ADDENDUM NO. 2

WEST DUSTON ROAD AREA SEWER, WATER, AND ROADWAY IMPROVEMENTS Salem, New Hampshire January 23, 2020

25 Vaughan Mall, Portsmouth, N.H. 03801 Tel. 603-436-6192 Fax. 603-431-4733	
WEST DUSTON ROAD PLAN & PROFILE	
WEST DUSTON ROAD AREA SEWER, WATER & ROADWAY IMPROVEMENTS	
TOWN OF SALEM, NH	
DWG NO P5	SHEET 18 OF 39

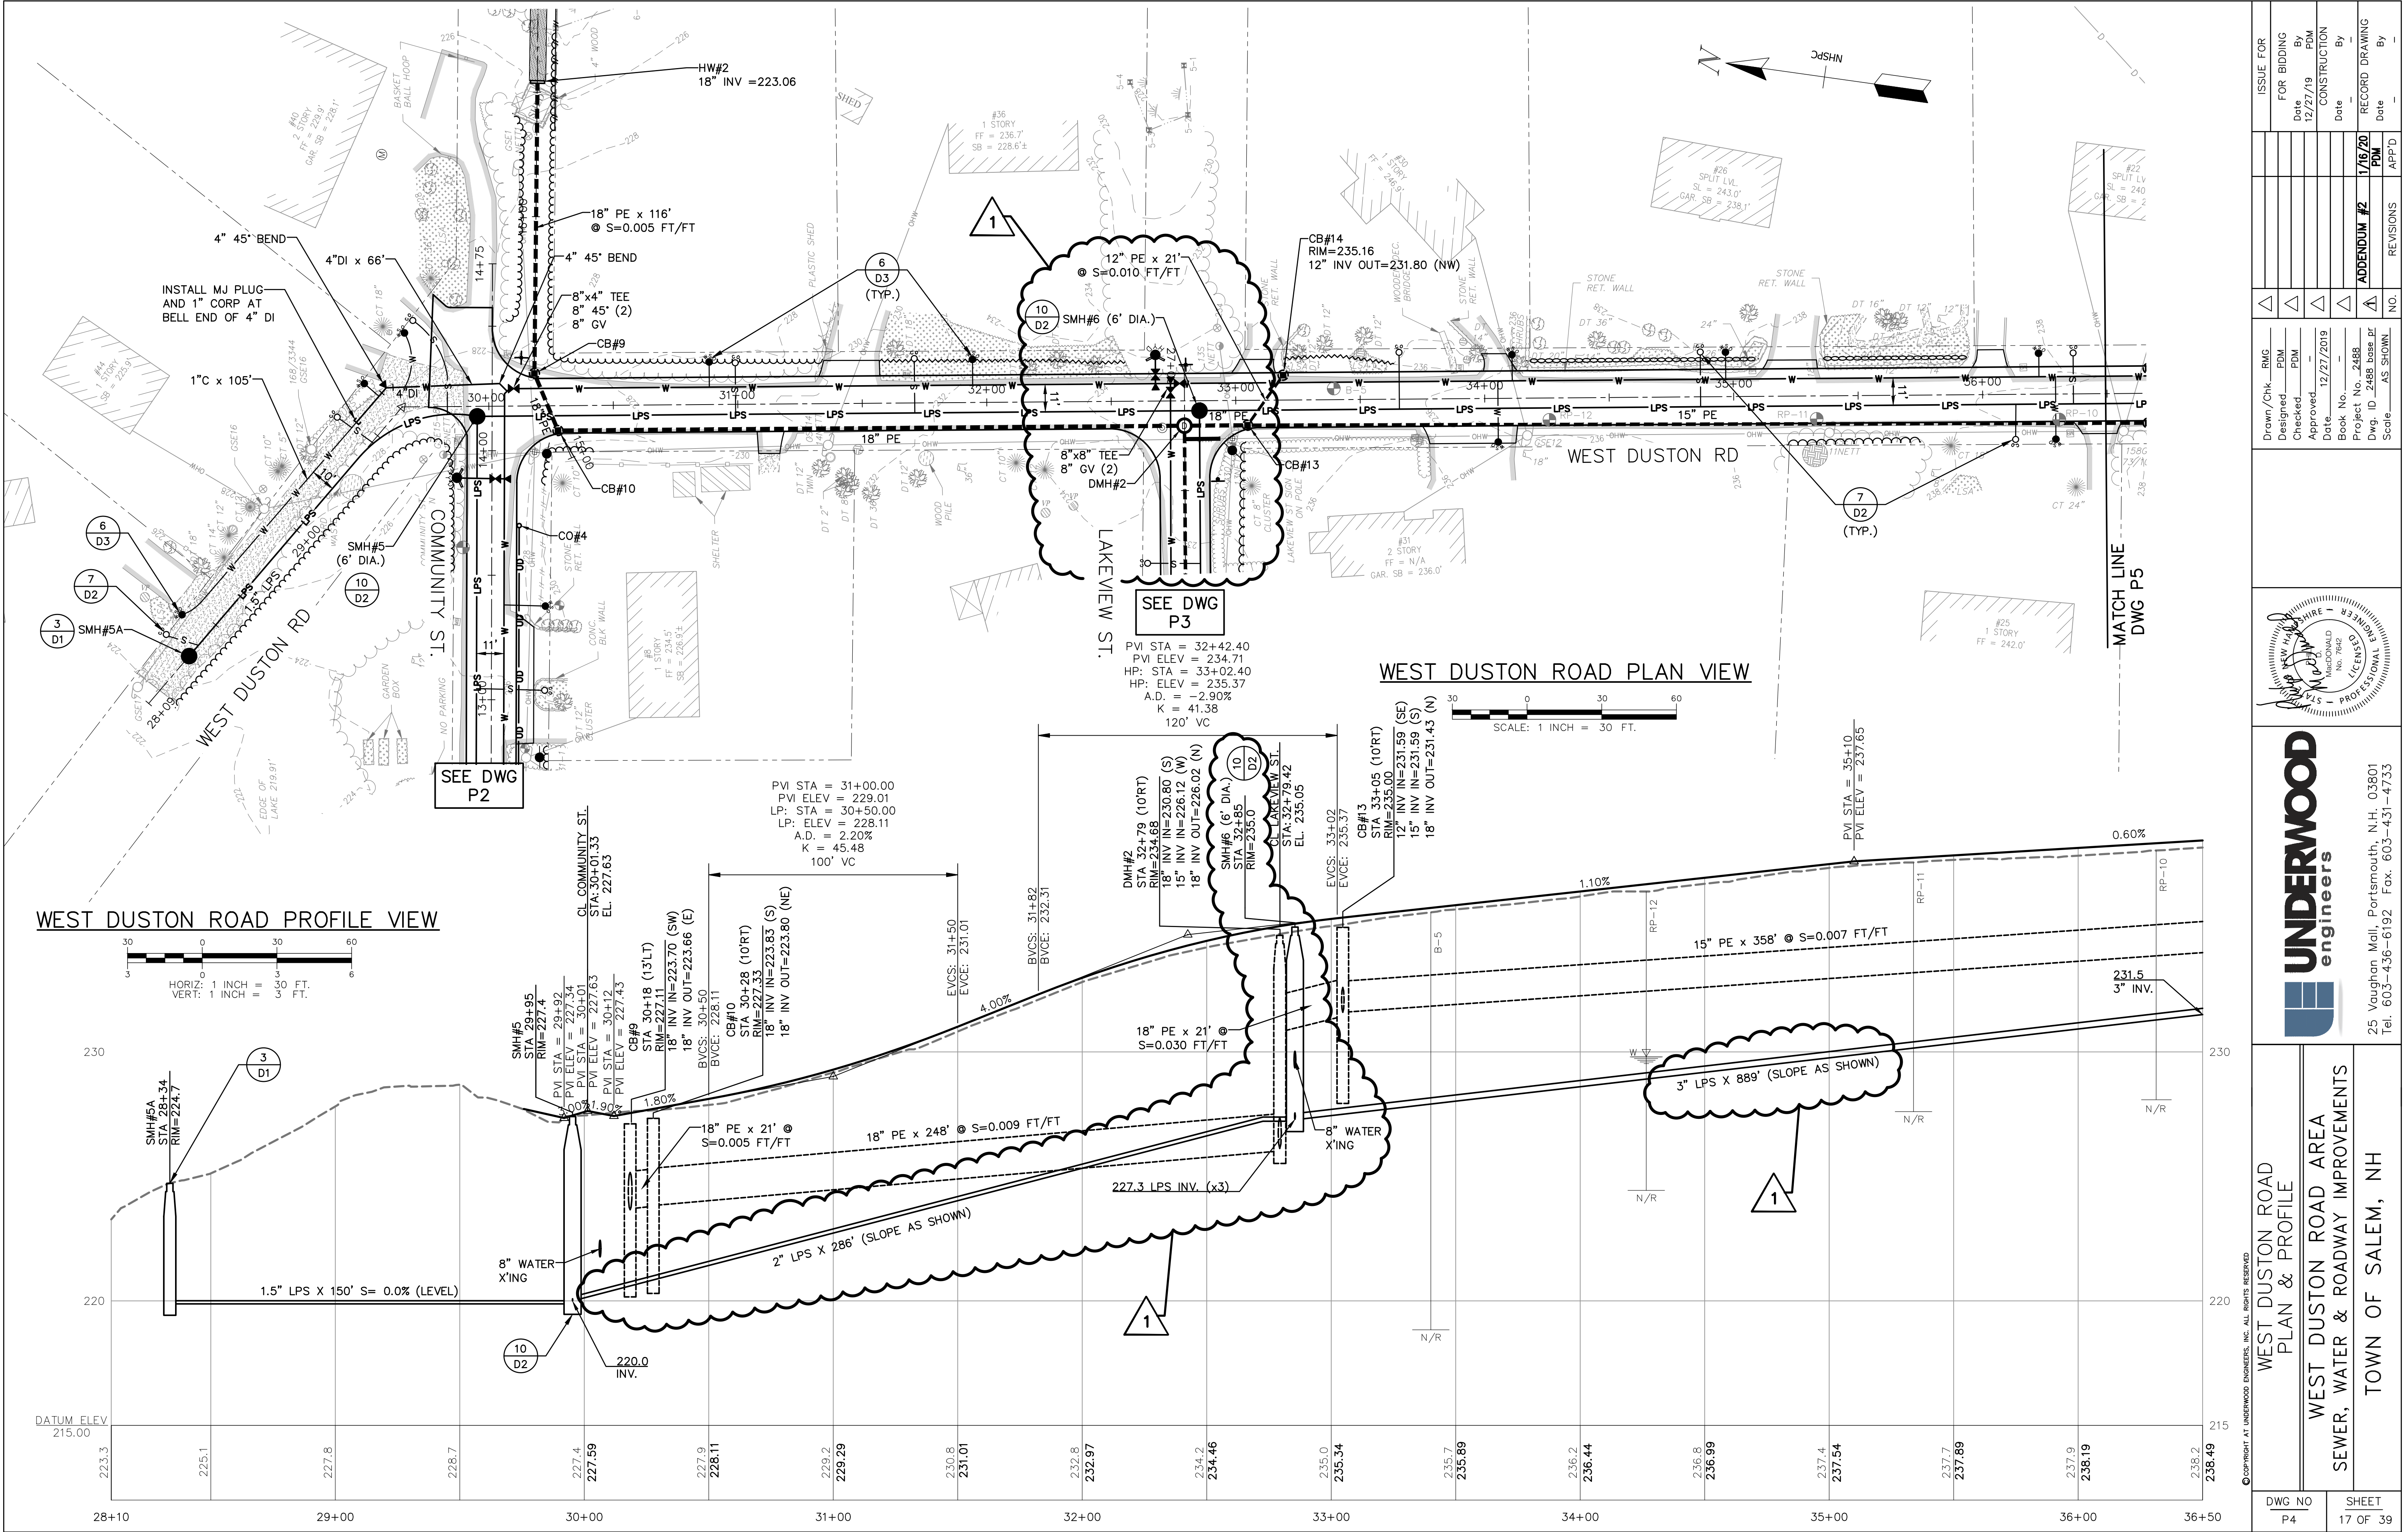
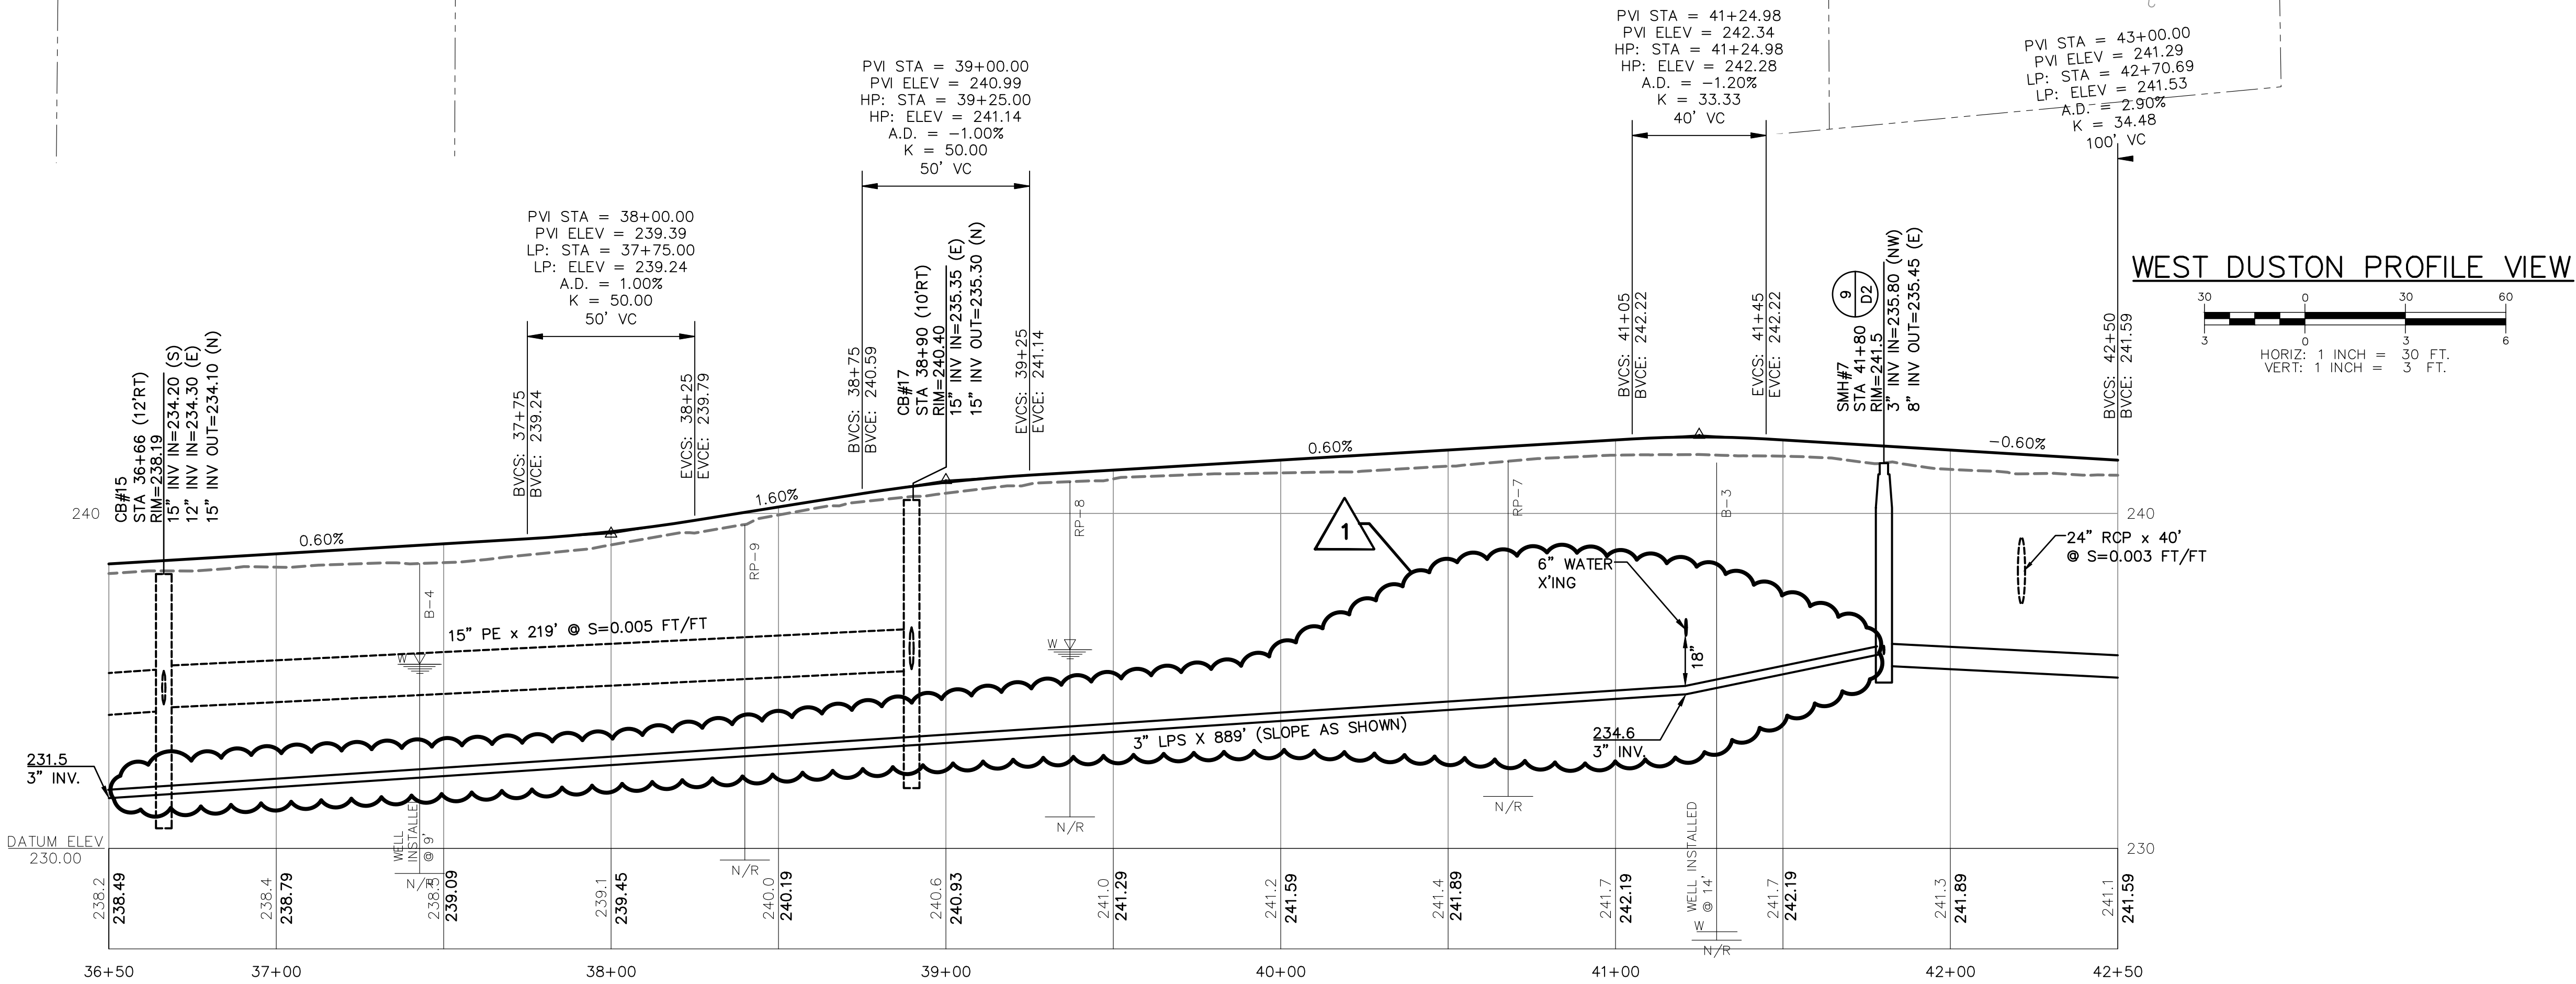
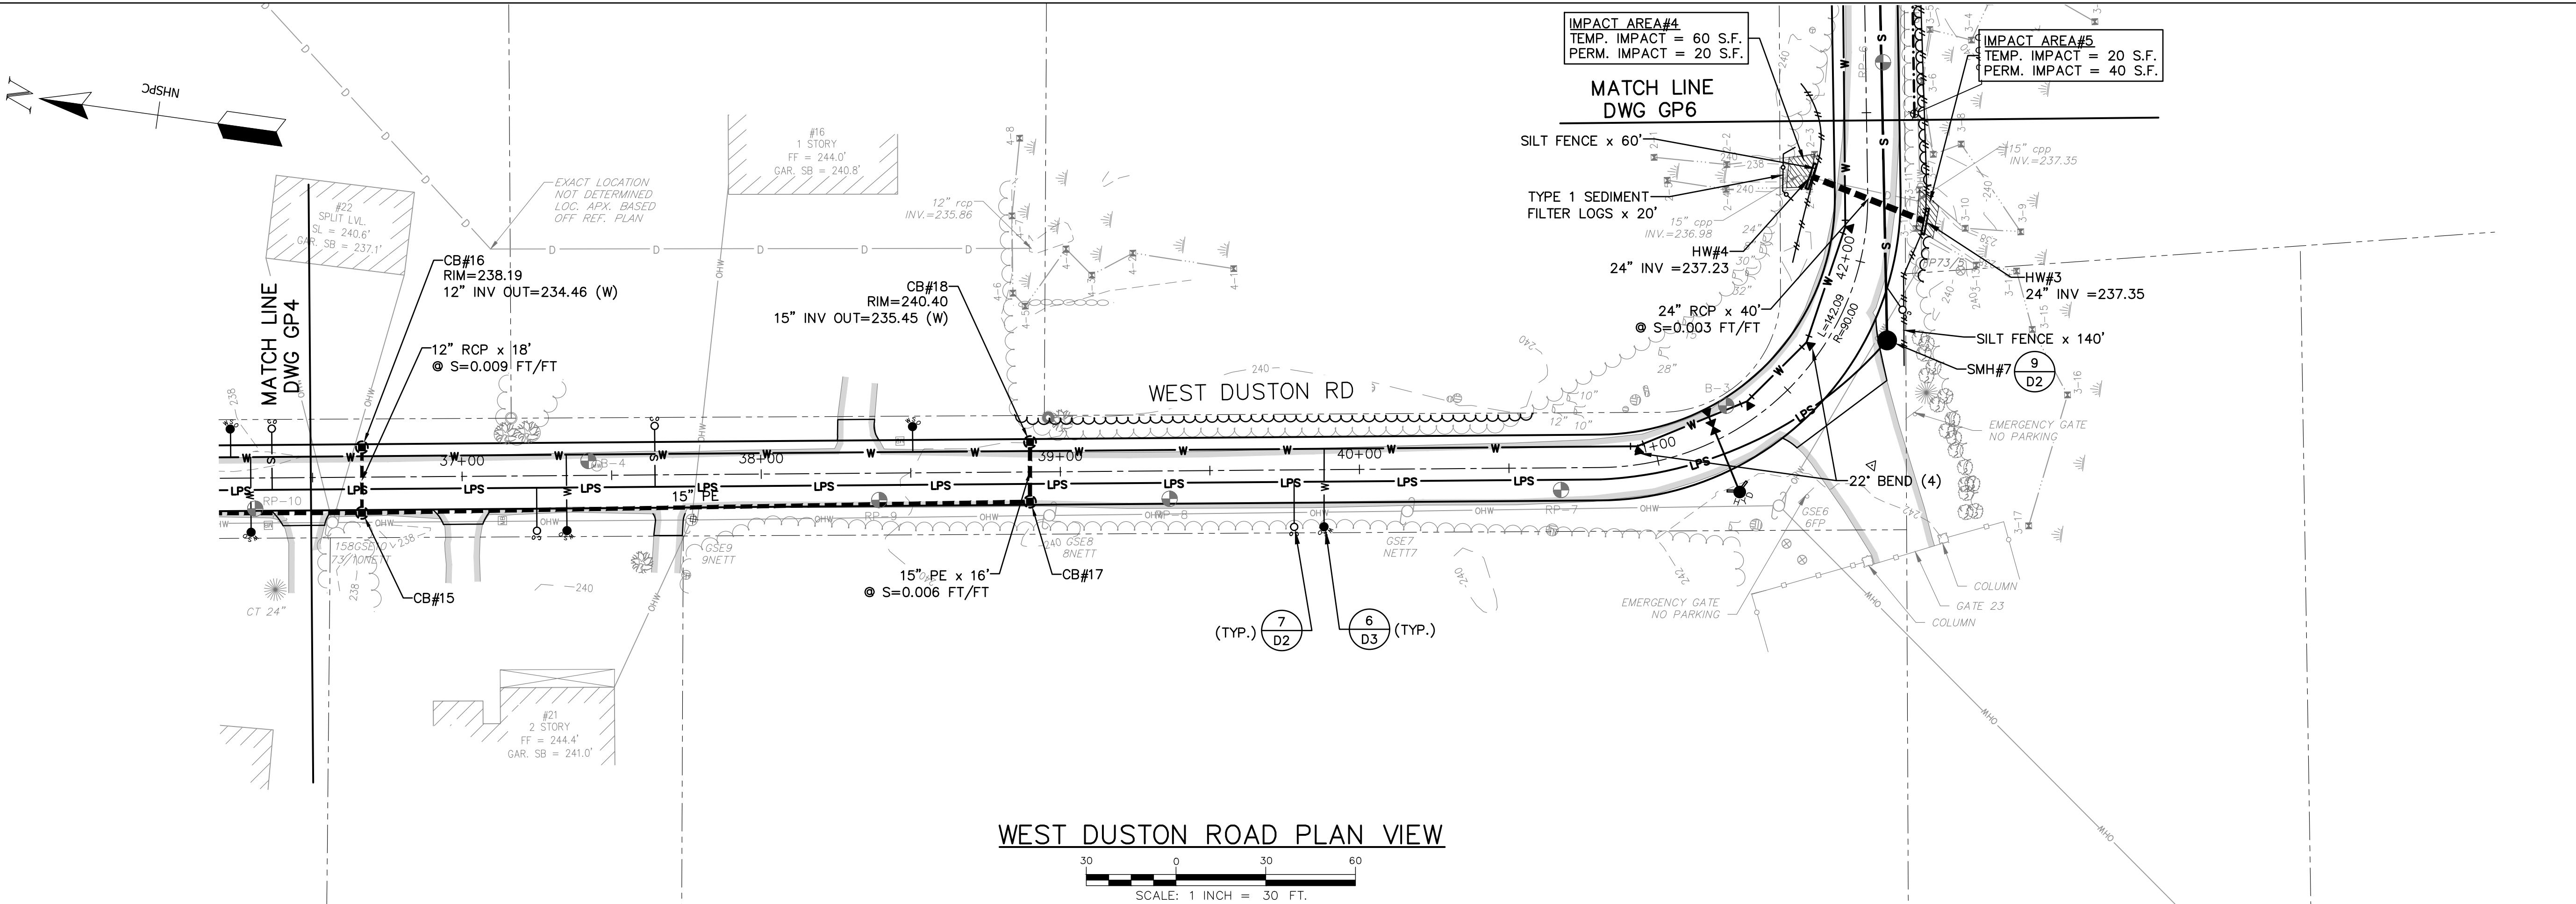
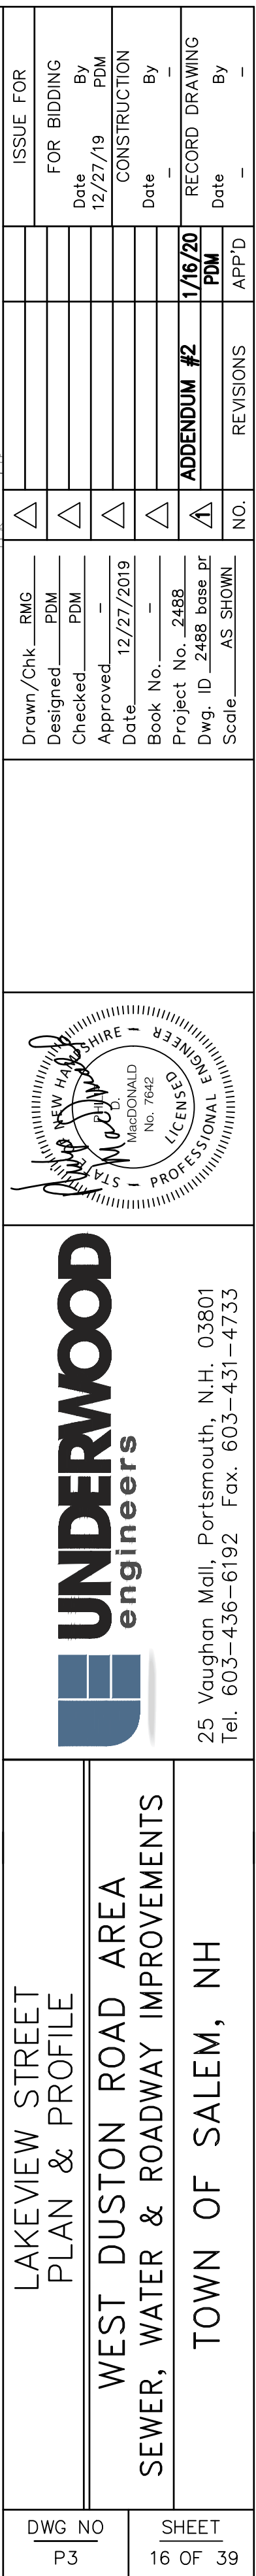
13. Drawing P5 (WEST DUSTON ROAD PLAN & PROFILE, ATTACHED)
 - **Replace** DWG P5 with Addendum No. 2, **DWG P5, Attachment "B"**. (Note, the LPS profile is revised to maintain 18" vertical separation.)

- **Change** the LPS invert elevation at STA 41+20 to maintain 18" vertical separation between the LPS and water main.
 - **Change** the length of the 3" LPS between SMH #6 and SMH #7 from "900" to "889".

Figure 1: From DWG D1 – SEWER DETAILS, STANDARD SEWER MANHOLE, DETAIL 1/D1

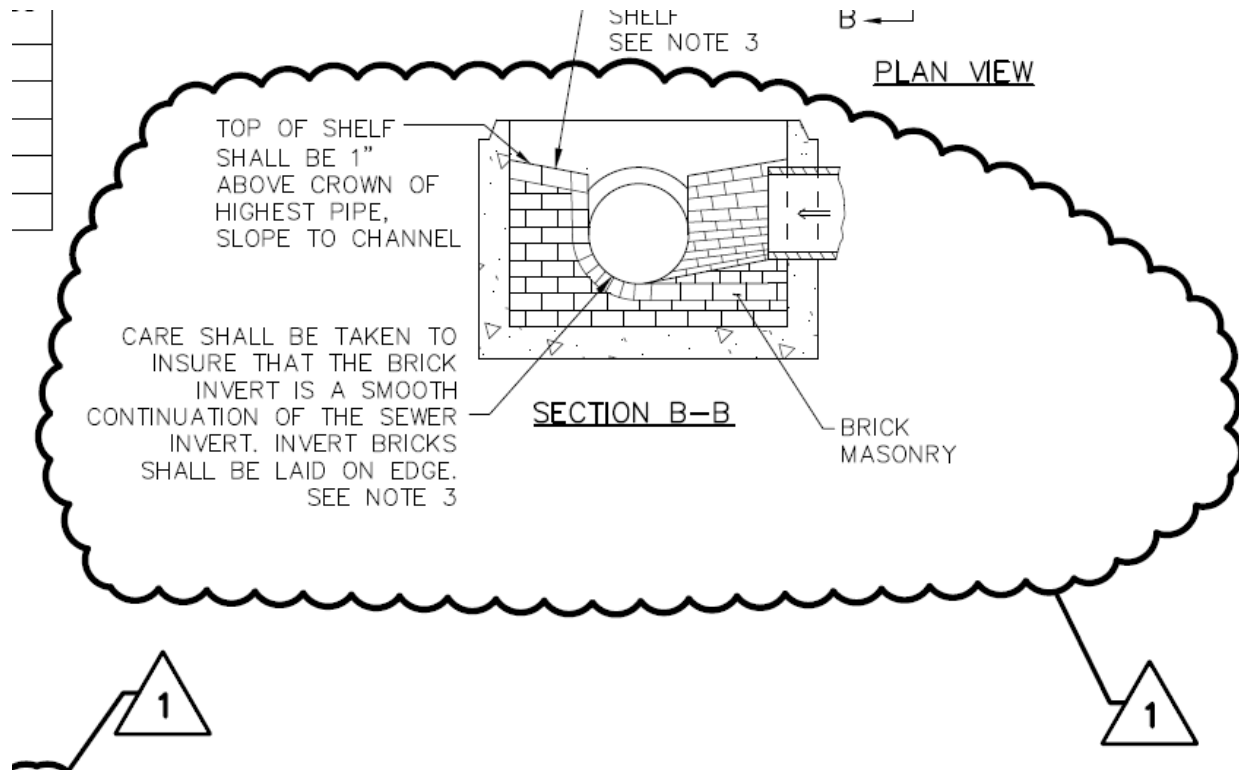
- Note 11 – **Change** NHDES reference in specifications to **ENV-WQ 704**.
 - **Replace** SECTION B-B with **Attachment "C", Section B-B**.
15. Drawing D2 (STANDARD SEWER TRENCH SECTION, DETAIL 5/D2)

Figure 3: From DWG D2 – GRAVITY – SEWER SERVICE plan view of sewer service to sewer main connection.

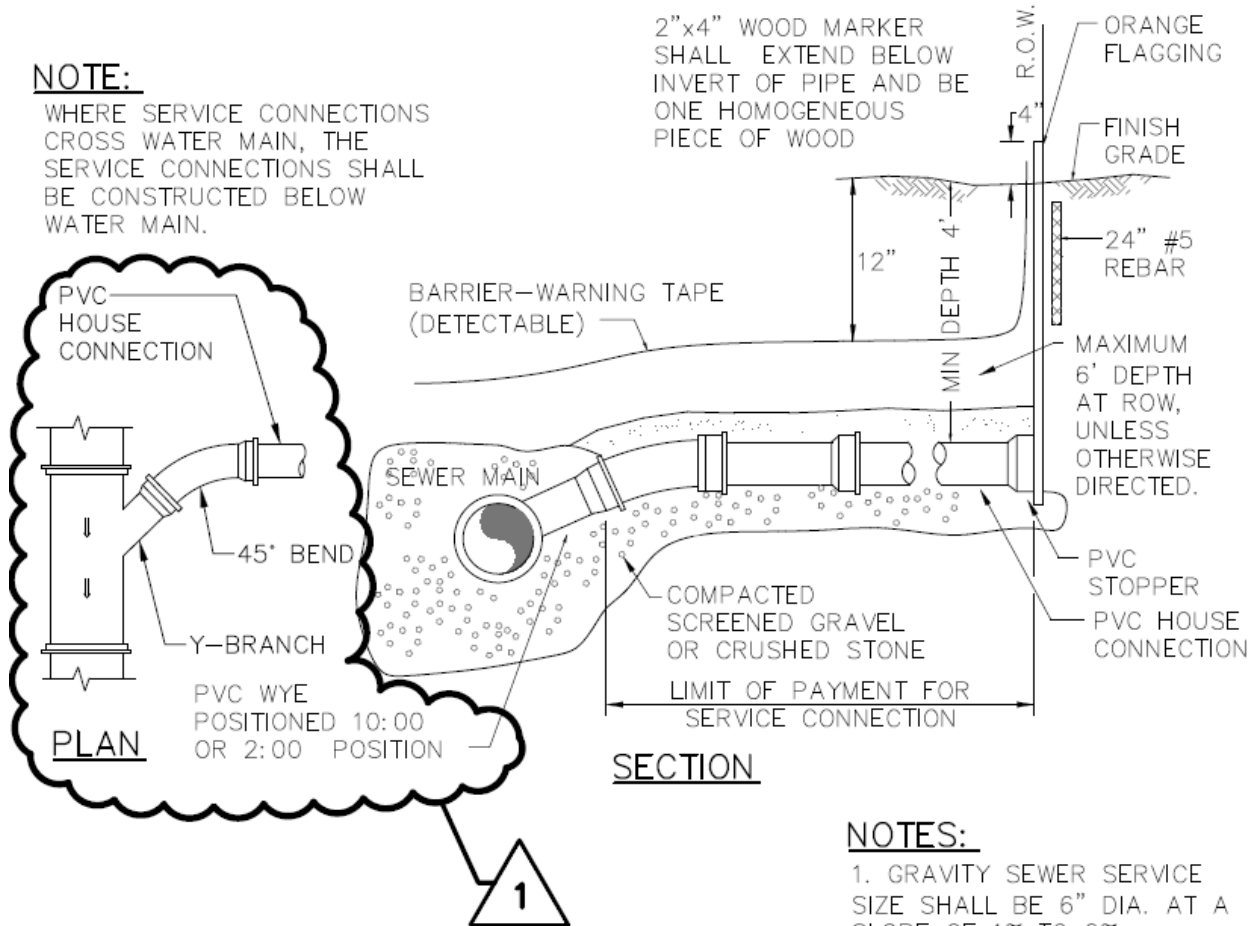
- **Revise** notes 15 to 17 with **Attachment "D", Notes 15 to 17**.
16. Drawing D2 (GRAVITY – SEWER SERVICE, DETAIL 6/D2)
 - **Replace** plan view of the service to main connection with **Attachment "E"**.

WHERE SERVICE CONNECTIONS CROSS WATER MAIN, THE SERVICE CONNECTIONS SHALL BE CONSTRUCTED BELOW WATER MAIN.

1. GRAVITY SEWER SERVICE SIZE SHALL BE 6" DIA. AT A SLOPE OF 1% TO 2% UNLESS SHOWN OTHERWISE.
